**MONTGOMERY COUNTY HISTORIC PRESERVATION COMMISSION**  
**STAFF REPORT**

<b>Address:</b>	3824 Warner St., Kensington	<b>Meeting Date:</b>	9/7/2022
<b>Resource:</b>	Primary One Resource <b>Kensington Historic District</b>	<b>Report Date:</b>	8/31/2022
<b>Applicant:</b>	Peter and Sharon Bartram	<b>Public Notice:</b>	8/24/2022
<b>Review:</b>	HAWP	<b>Staff:</b>	Dan Bruechert
<b>Case No:</b>	1003102	<b>Tax Credit:</b>	n/a
<b>PROPOSAL:</b> Partial Demolition, Tree Removal, Building Addition, and Rear Deck Construction

SITE PLAN

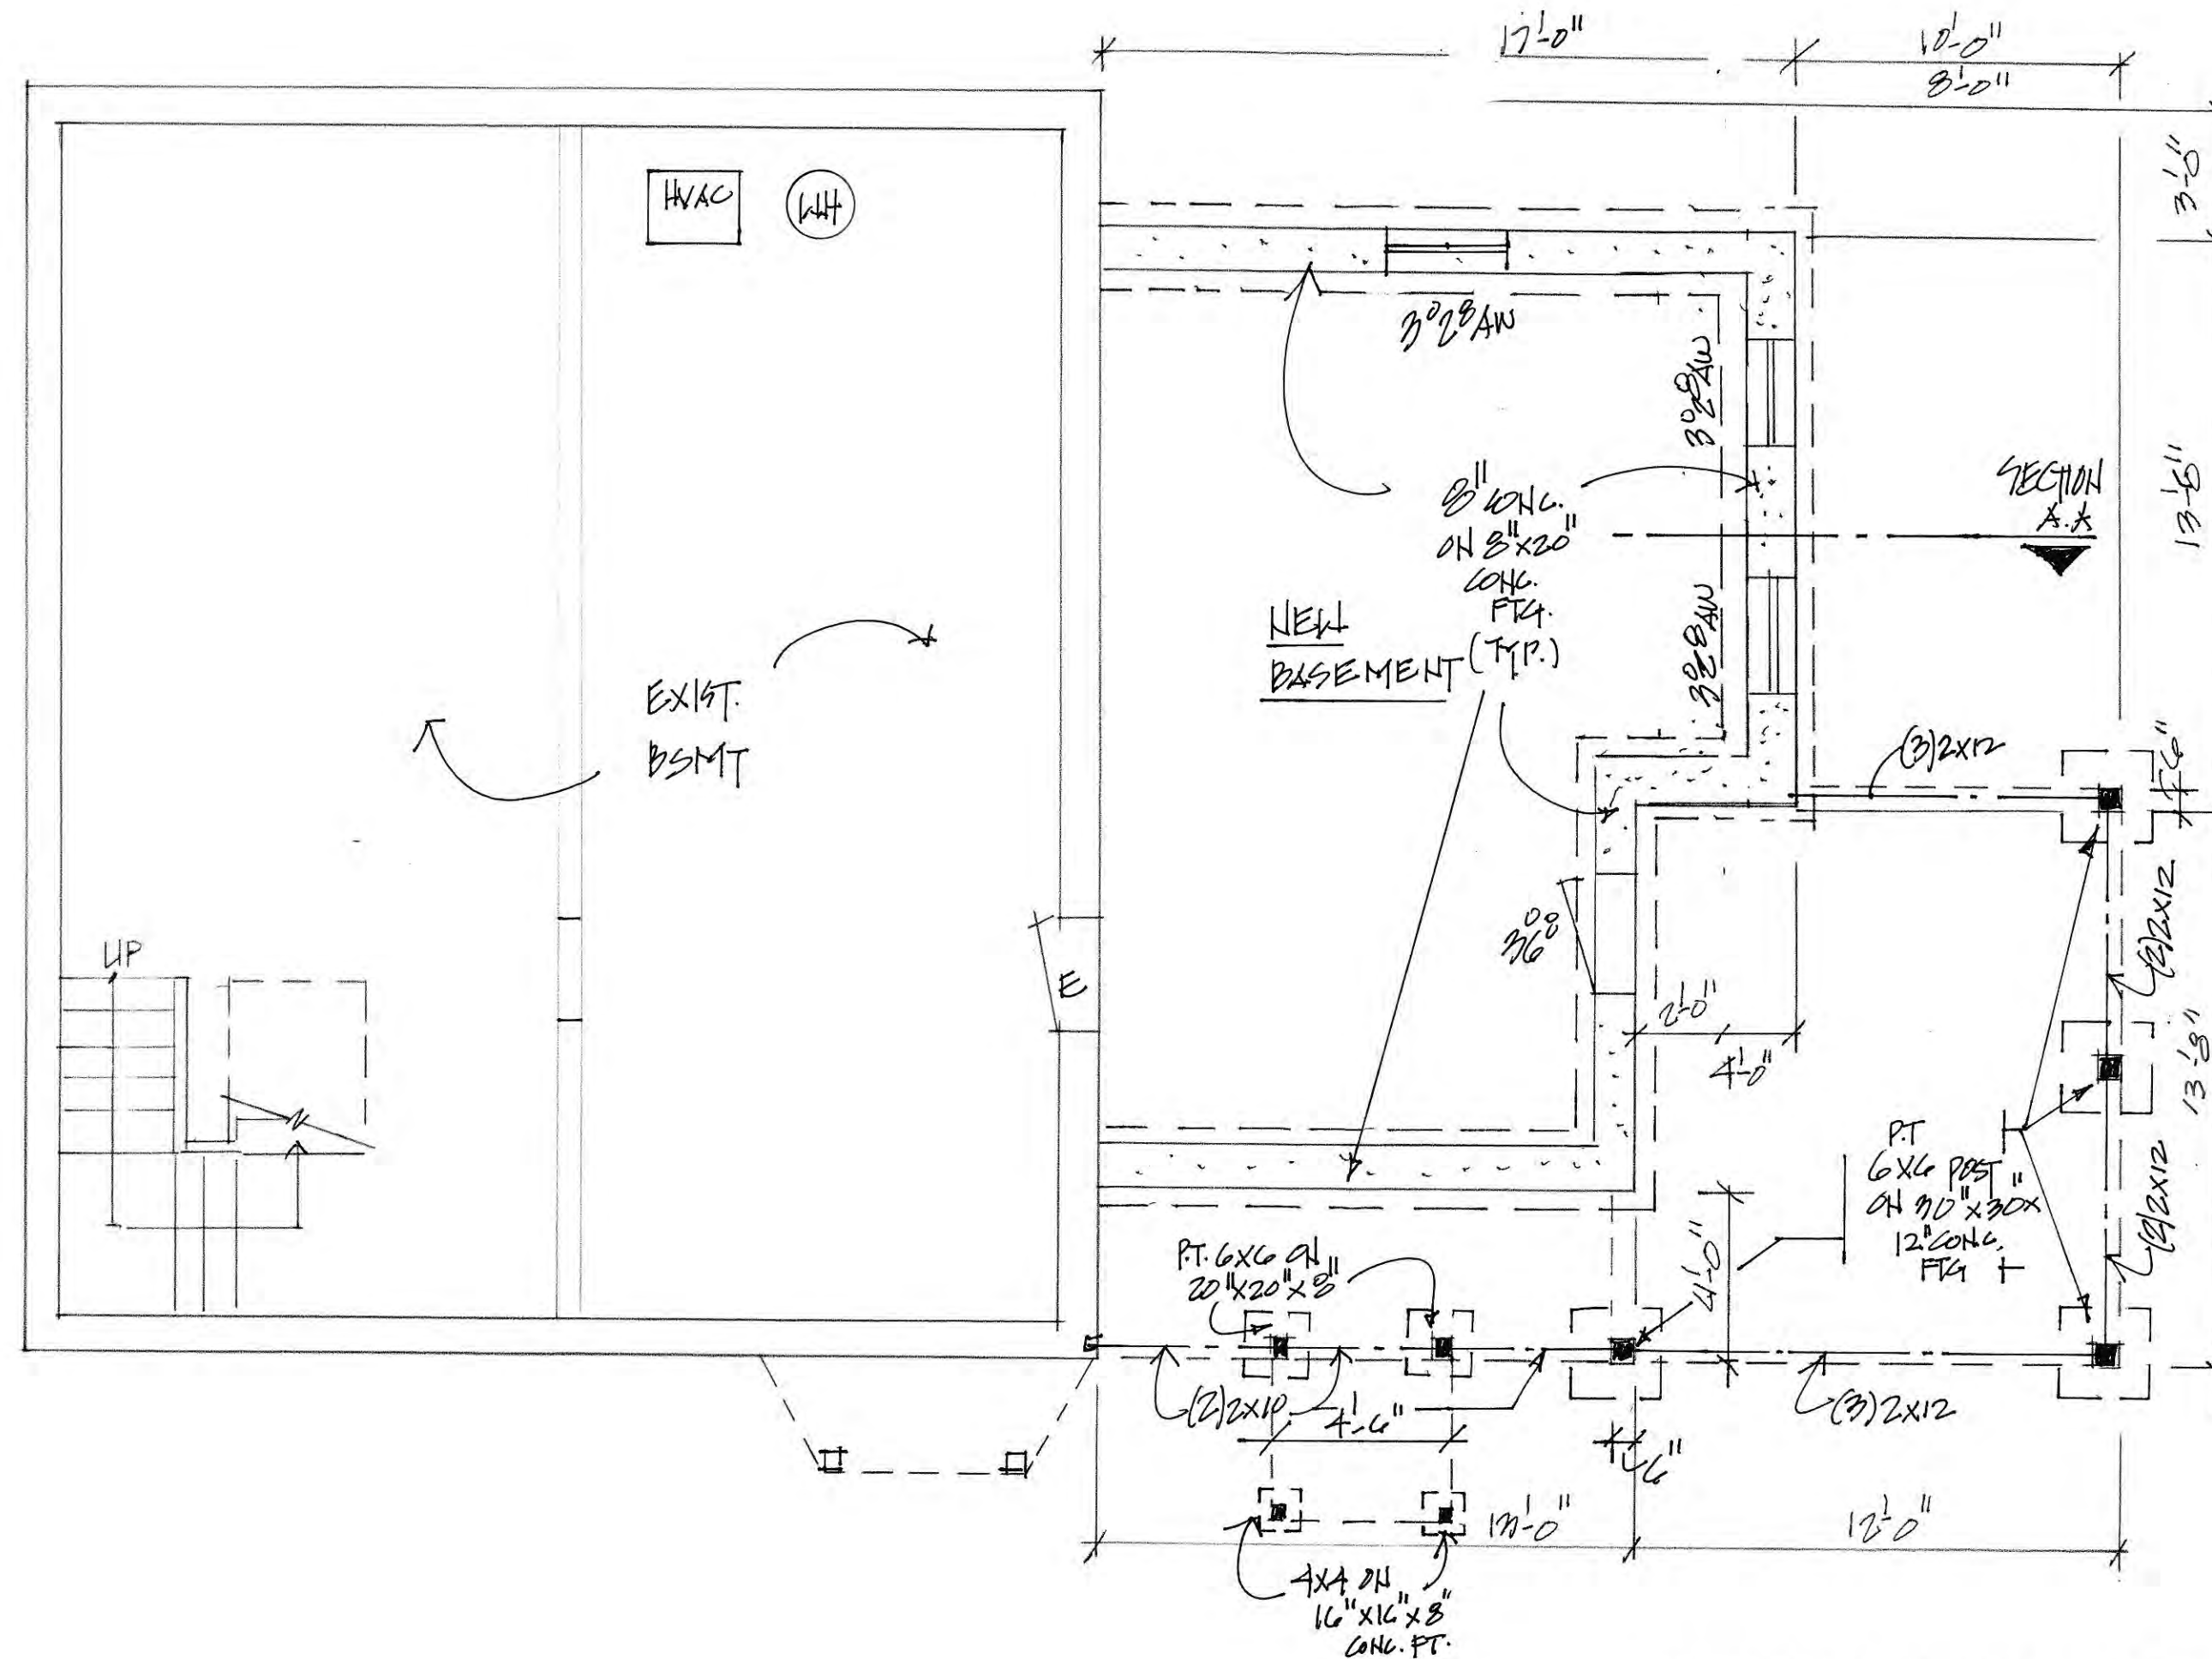
In the middle of the non-historic deck, there are three maple trees. These trees are not historically significant and have trunks ranging from 8” to 12” (eight to twelve inches) d.b.h. The trees are in the location of the proposed building addition, discussed below.

Staff finds these trees are not historic and their removal will not impact the mature tree canopy of the surrounding “Garden Suburb.” Staff does not find it necessary to require additional re-planting on site, as the property has several other trees on the lot that contribute to the overall character of the district and

REAR ELEVATION

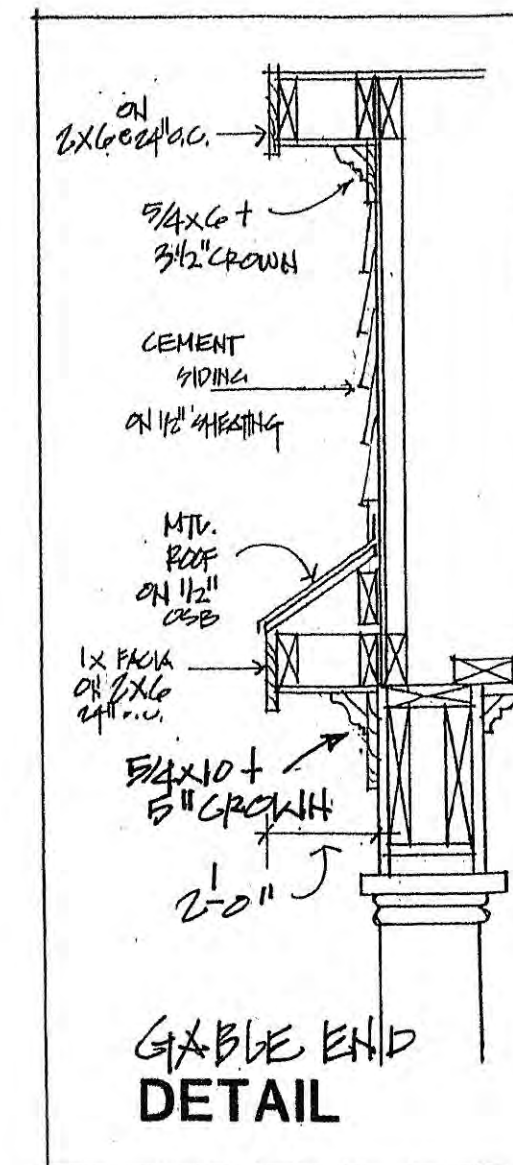
At the rear of the existing house, the applicants propose to construct a two-story, rear gable addition, measuring 27' 8" × 17' (twenty-seven feet, eight inches by seventeen feet) with a painted concrete foundation. The side walls of the proposed addition are inset from the historic wall planes (3' 6" on the left (east) wall and 4' on the right (west) wall. The wood clapboard siding with corner boards will match the siding on the non-historic bay (discussed above) and not the Dutchlap siding on the principal mass of the historic house. Windows on the right and rear elevations of the addition will be one-over-one sash windows, while windows on the right side will be smaller square casement windows. The rear gable architectural shingle roof ridge is significantly lower than the historic ridgeline.

Staff finds the proposed addition will be visible from the right-of-way along Freeman Place. Staff additionally finds the proposed design and massing of the proposed addition is compatible with the design and scale of the historic house. Staff finds the lower roof height and wall insets help to make the addition subservient to the historic house. The use of the wood clapboard siding further aids in differentiating the addition from the historic construction, consistent with the requirements of Standard 9. In most instances, Staff would not support the square casement windows proposed on the left elevation. However, because the subject property has a narrow side setback to the property to the east, and the addition wall is inset from the historic wallplane by 3' 6", Staff finds the addition wall will not be highly visible from the right-of-way and finds the windows are appropriate in this application. Staff recommends the HPC approve the rear addition under 24A-8(b)(2) and (d) and Standards 2 and 9.

# RIGHT SIDE ELEVATION

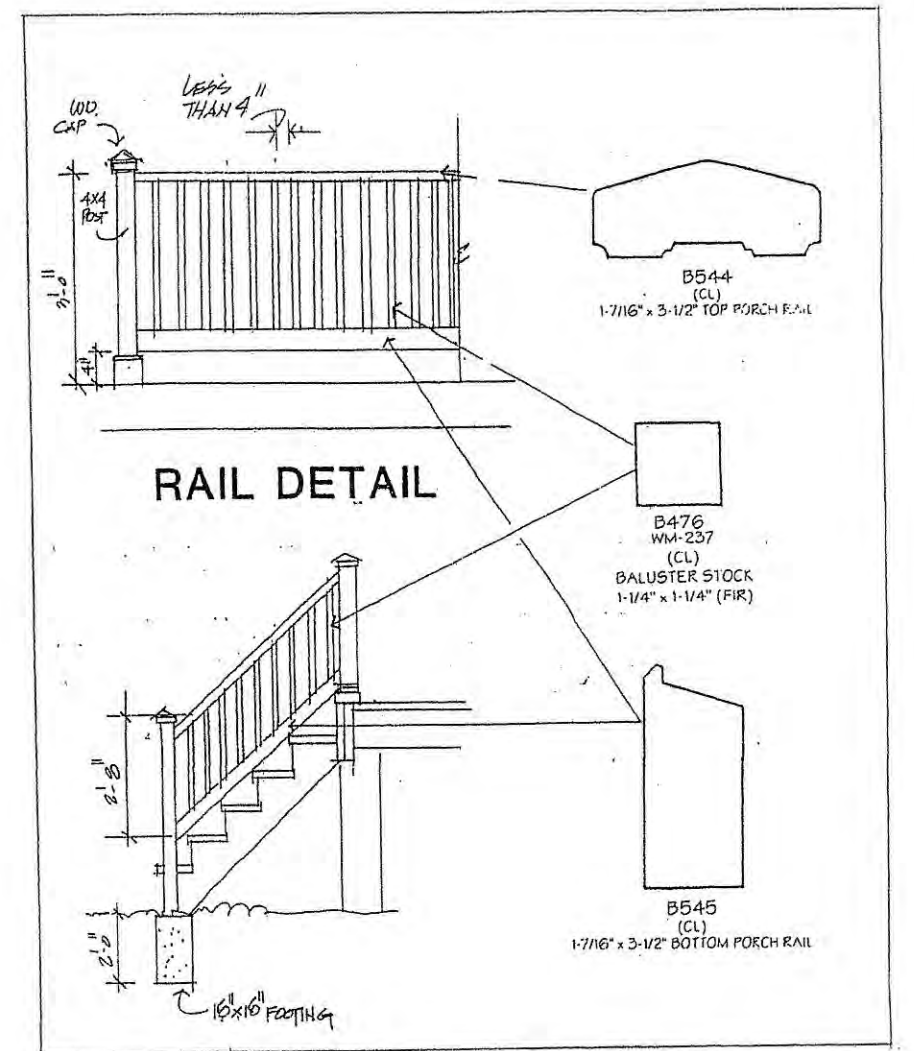
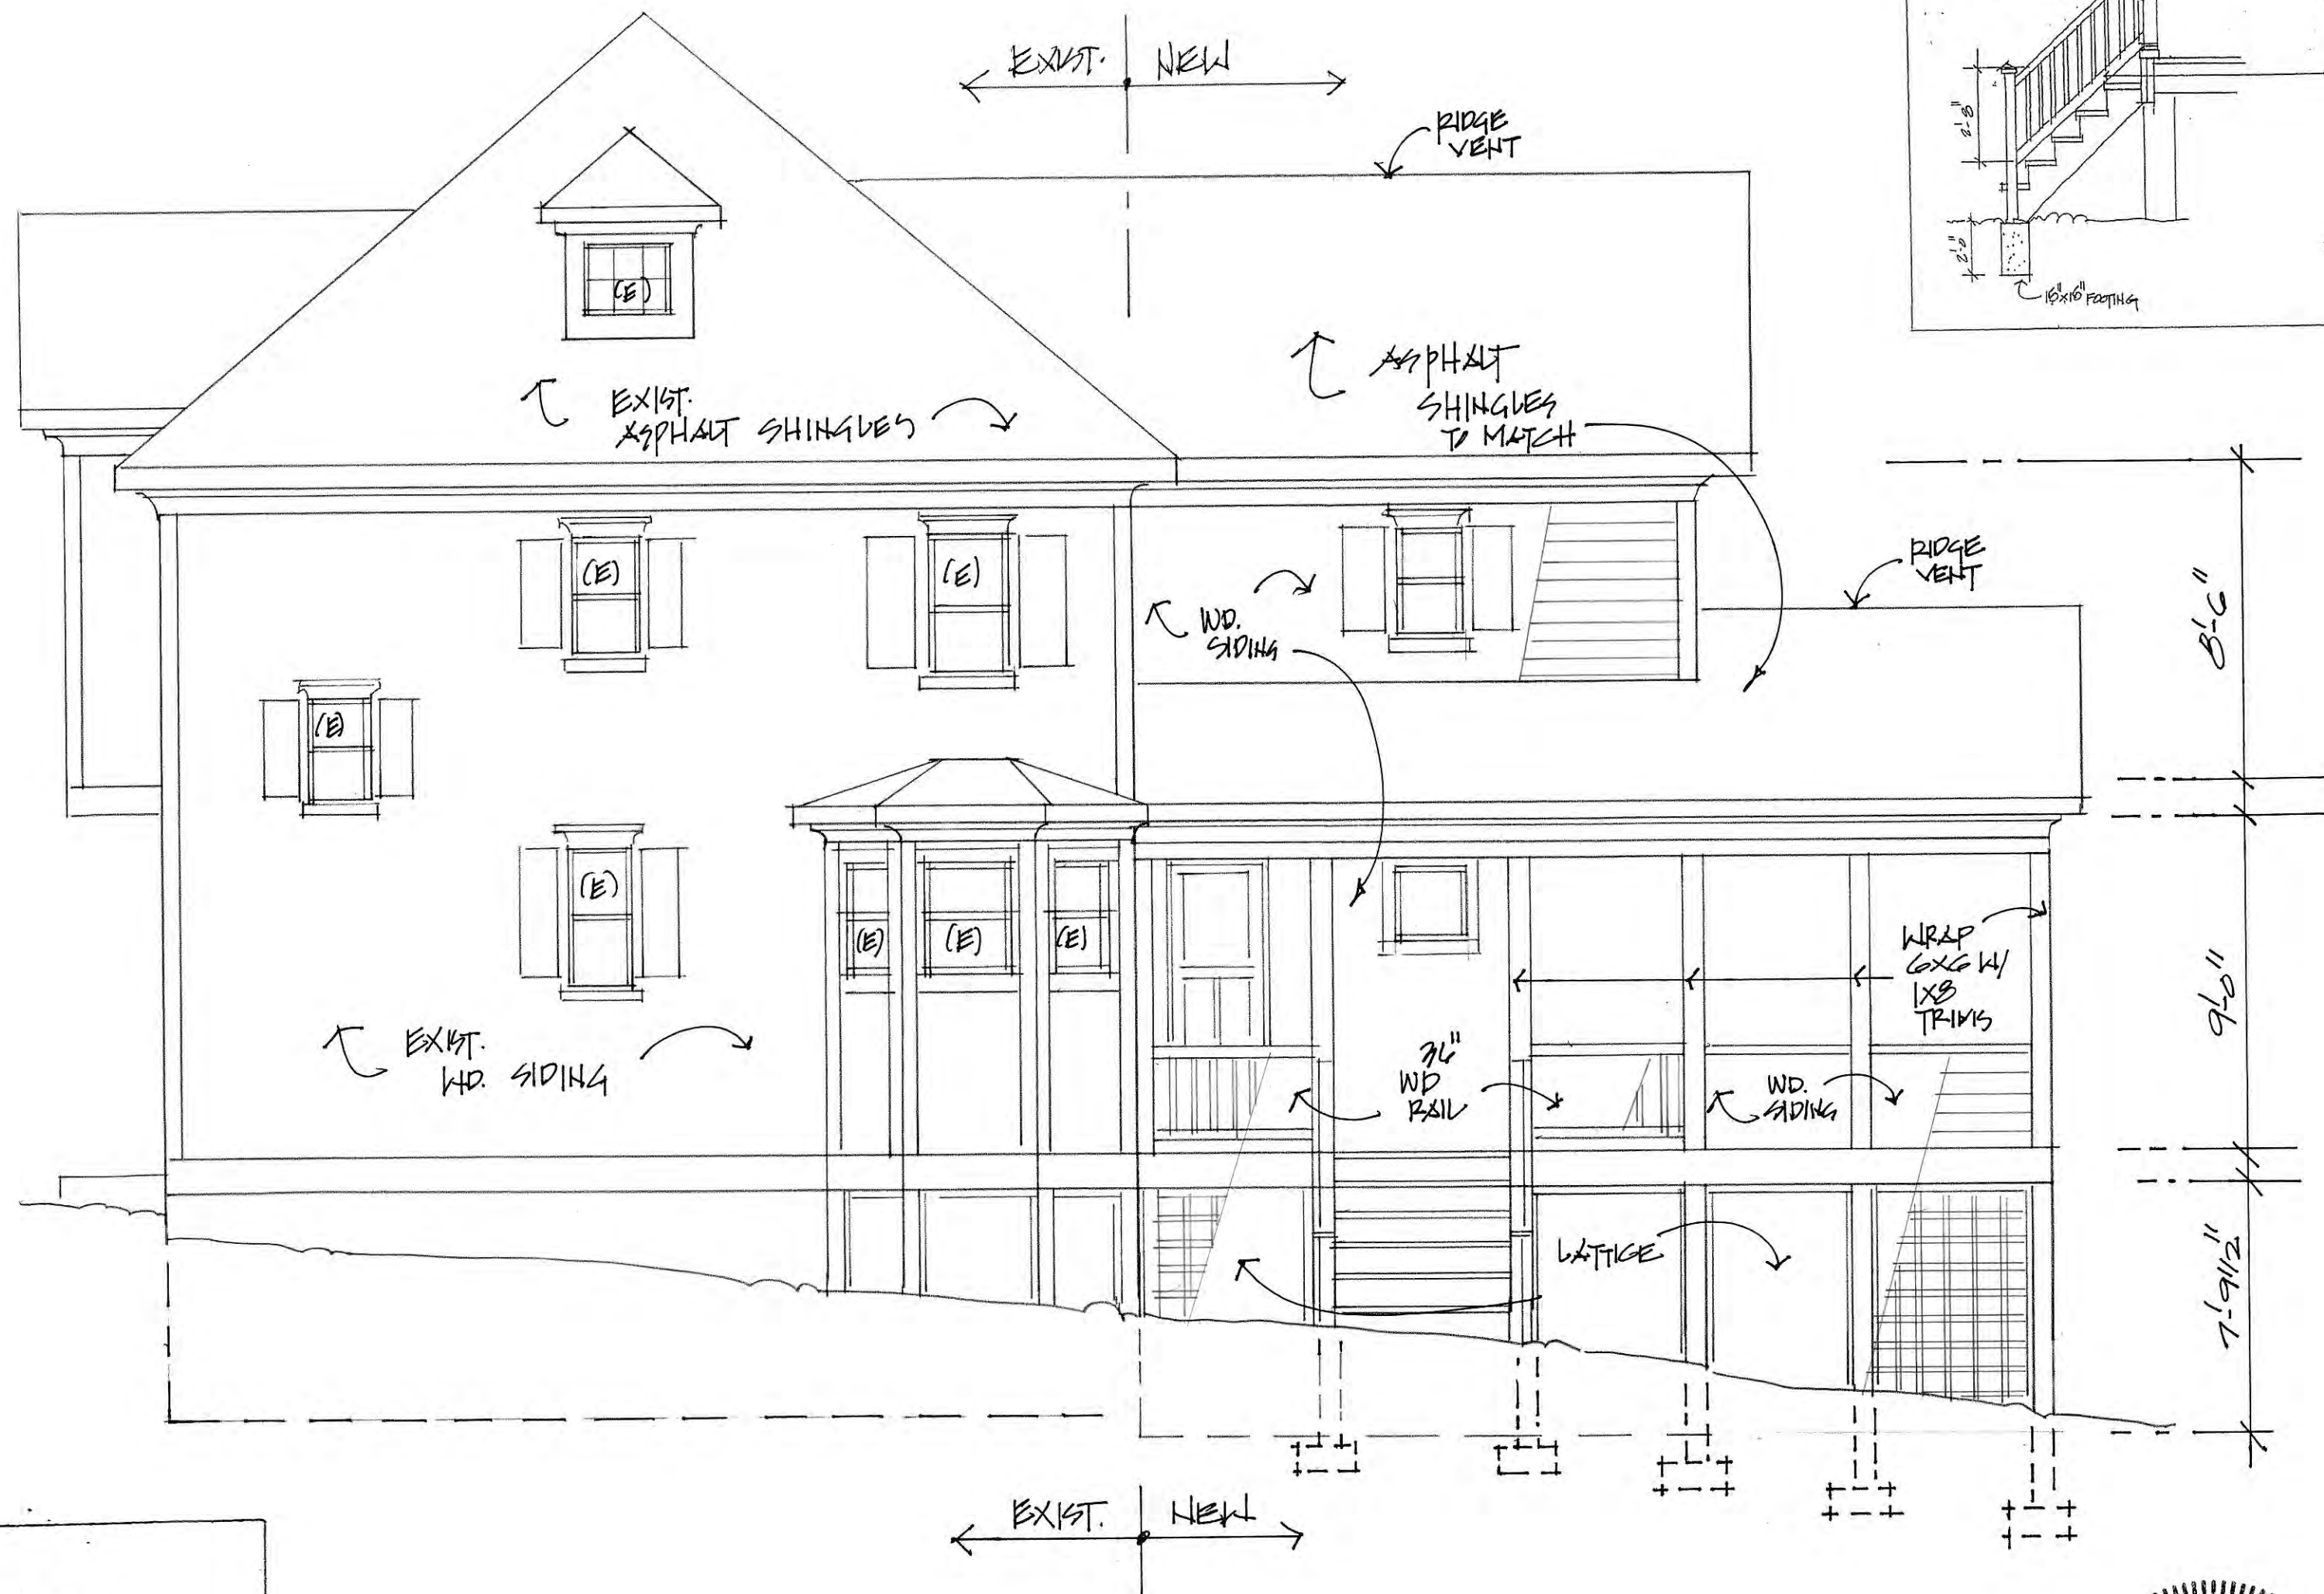
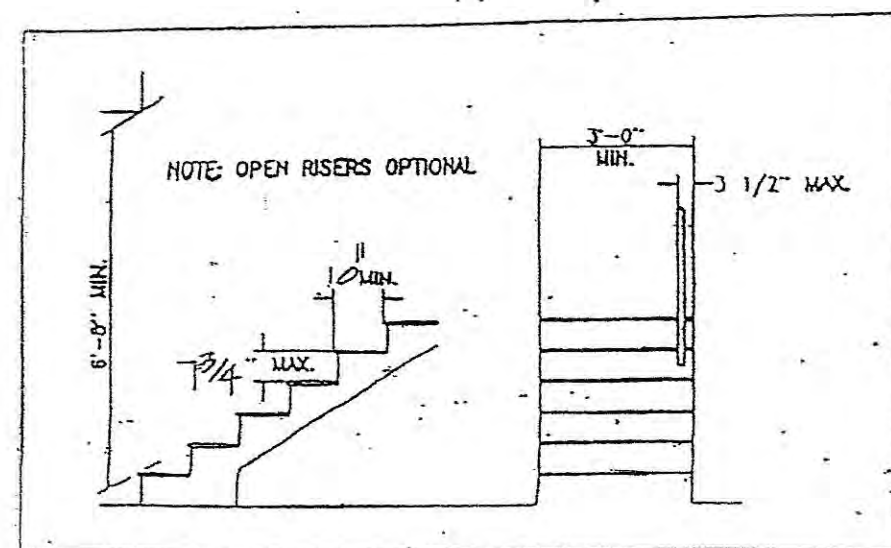
On the right (west) elevation there is a non-historic bay with three six-over-six sash windows. The applicants state these sashes fit poorly. The applicants propose to remove and replace these windows with new one-over-one windows.

Staff finds the existing windows are not historic, are an incompatible configuration, and do not contribute to the historic character of the house, and may be removed under 24A-8(b)(1), (2), and (d) and Standard 2.

On the right elevation and to the rear of the new addition, the applicant proposes to construct a new deck with a screened-in porch. The deck and porch are supported by wood posts with wood lattice screening below. The deck has a wood railing and stairs with wood square posts. The screened-in porch section, to the rear, replaces the railing with 36" (thirty-six inches) of painted wood siding and has a rear-facing gable roof.

Staff finds the deck and porch are both compatibly designed and do not overwhelm the size of the historic construction. Staff recommends the HPC approve the deck and porch under 24A-8(b)(2) and (d) and Standards 2, 9, and 10.
